(54) AERODYNAMIC TRUCK LIGHT COVER BEZEL AND LENS

UNITED STATES PATENT AND TRADEMARK OFFICE CERTIFICATE OF CORRECTION

PATENT NO. : Des. 511,220 S

FIG. 2

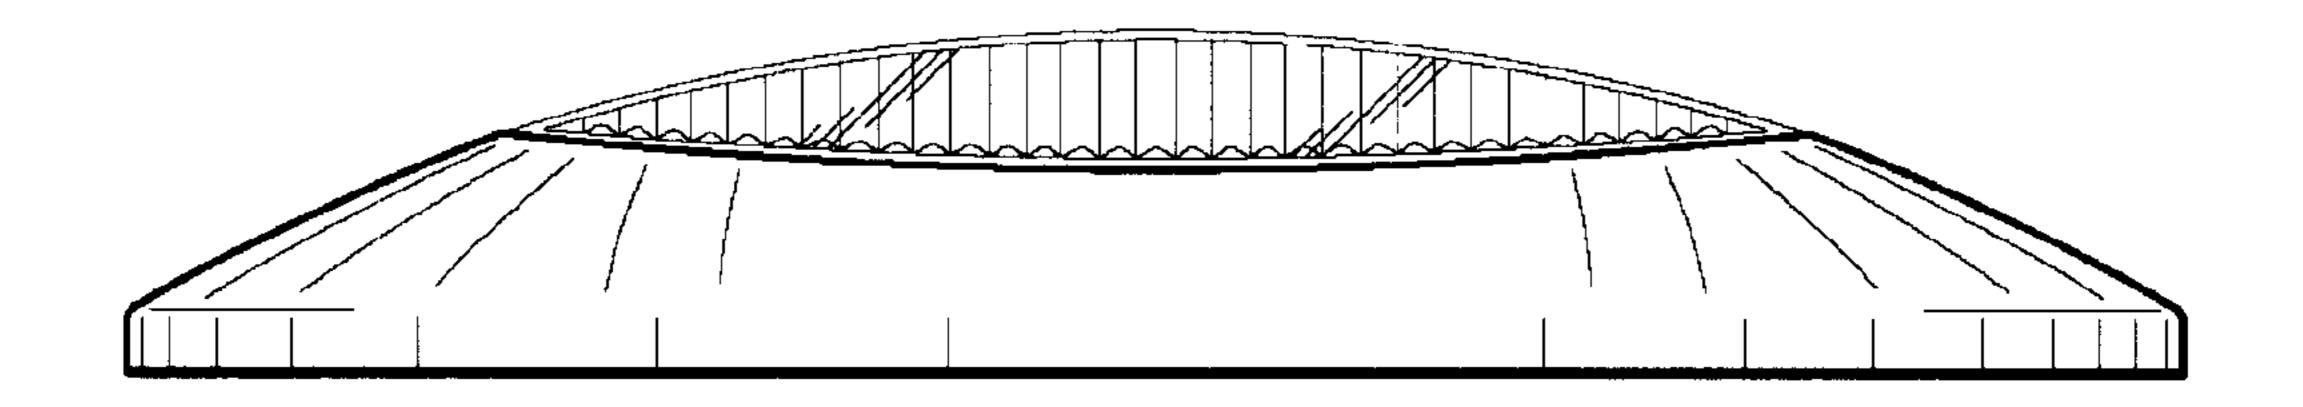
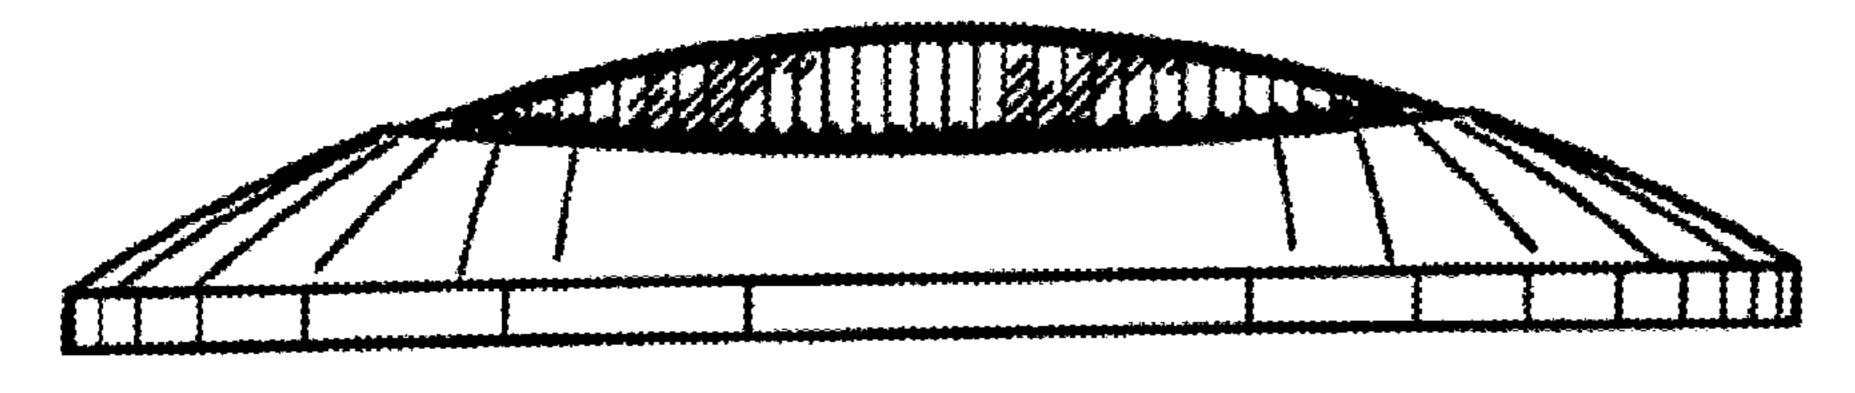
In the drawings, Sheet 1, Fig. 2, should be replaced with the following drawing to conform with Fig. 2 as originally filed illustrating that the lens is not flush to the light cover bezel:
